**SUBJECT:** Advisory Committee for Persons With Disabilities Annual Report

# **Accessibility Audit**

## **Halifax Old City Hall** Halifax, Nova Scotia

project  
**BF RENOVATIONS  
 HALIFAX OLD CITY HALL**

**Section S. Signage**

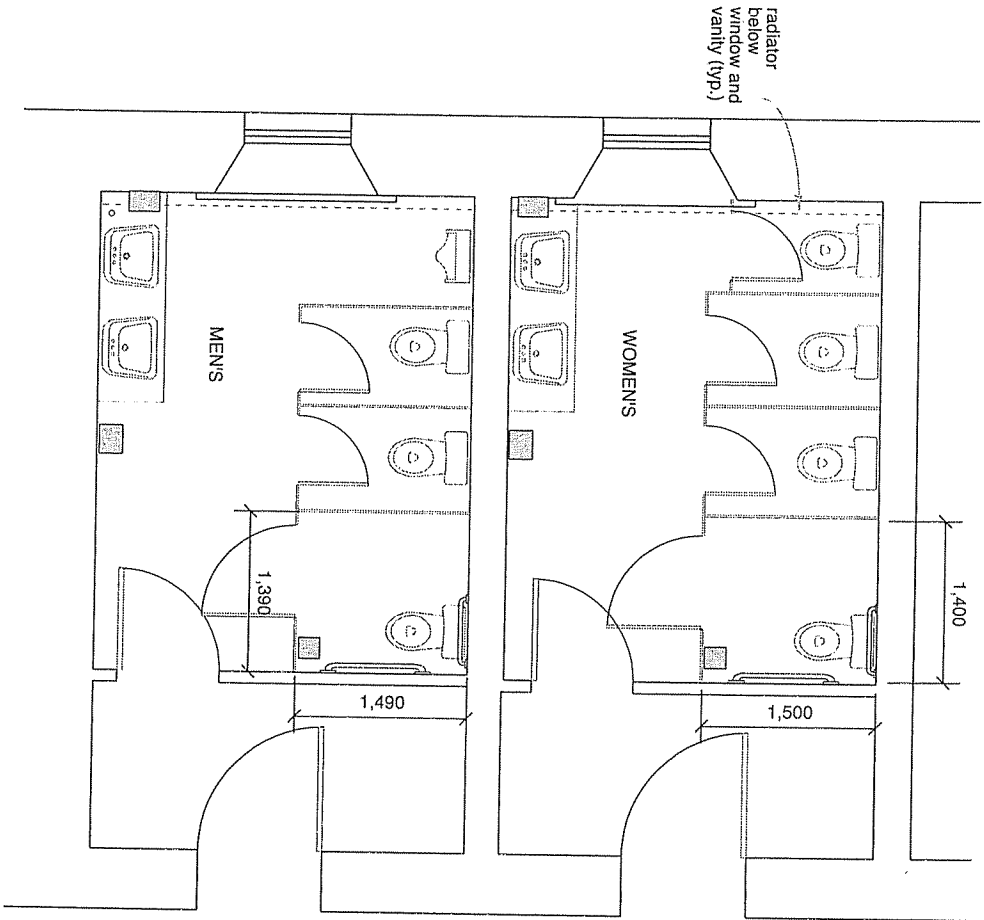
Signage is required to indicate the BF entrance or the Path of Travel leading to the entrance, and if not obvious, the location of elevator, BF washrooms, telephone, areas of refuge (if any), and means of egress.

The only signage present for people with disabilities occurs near the main entrance indicating “Wheelchair Accessible Argyle Street Entrance.” At Argyle entrance, one sign directs visitors to the main door, a second hand drawn sign states: “Jan. 14/06. Notice - Only couriers, persons with disabilities is (sic) to use this door. All couriers must sign in at the front desk.”

A new sign as described in the NSBCR would be desirable to designate the BF entrance at Argyle.

WASHROOM PLAN - FLOOR 3

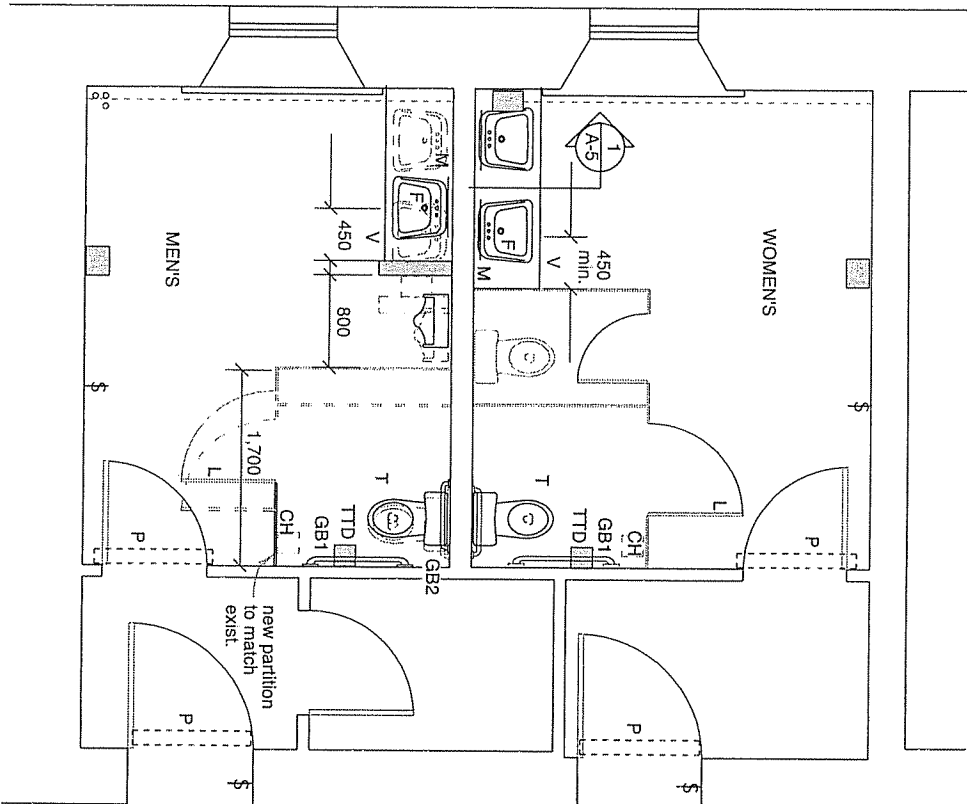
1. Women's barrier free stall partitions are to remain unchanged on floor 3, since conflict between inswinging room door and stall door does not occur here, as it does elsewhere. The existing 1400 dimension was considered to be adequate in this location since there will be and expanded stall in level 2 women's.
2. Renovations at this stage are primarily functional, due to budget constraints.
